NEW PRODUCT INFORMATION

SUBJECT: AD50-90 (BB301158) replaces AC51-00 (CM231158)

Products Affected: All kits that include the AC51-00

Effective Date: 1-MAY-08

AD50-90

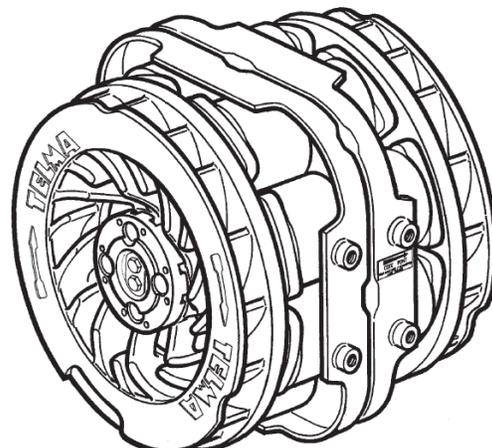
We are pleased to announce the introduction of the AD50-90 as a replacement for the AC51-00. The AC51-00 will not be available for future orders and all kits that use the AC51-00 will be transitioned to the AD50-90.

The AD50-90 is a comparable Telma model to the AC51-00 in terms of output brake torque.

The AD50-90 is advantageous to the AC51-00 in terms of size, weight, and design. The AD50-90 is 2.2 inches (60mm) shorter in length than the AC51-00 and it is 51 pounds (23kg) lighter.

The AD50-90 is also 2.3 inches (58.7mm) shorter flange-to-flange so with AD50-90 the drive shafts on either side of the Telma need to be 1.15" longer.

Power and ground connections are similar but with different connecting blocks.
